ADVANCED RELEASE

TO: Holders of RR300 Series Operations and Maintenance Manual, Publication CSP 21009.

Reason: Revised inspection procedure.

COMPRESSOR FRONT MATING RING SEAL INSPECTION/CHECK

Compressor Front Mating Seal Ring - Inspection/Check
FIG. 801/TASK 72-30-15-990-801

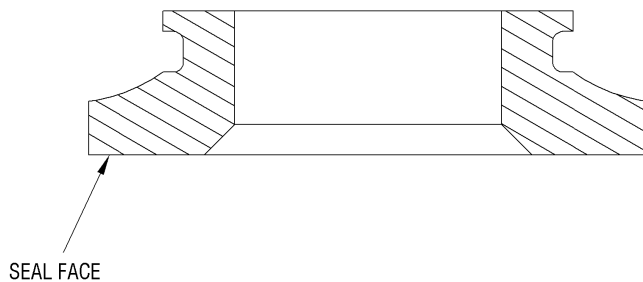
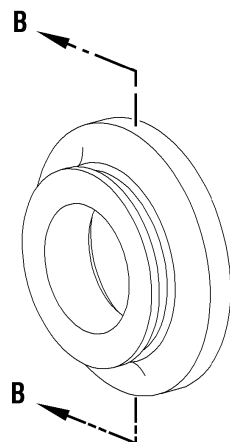
(1) Do the visual inspection of the compressor front mating ring seal.

(a) Do a visual inspection of the compressor front mating ring seal to the limits that follow:

ITEM	SERVICEABLE LIMITS	REPAIR LIMITS	ACTION NECESSARY
Seal face			
- Nicks, scratches or burrs	None permitted.	Not repairable.	Replace the compressor front mating ring seal.
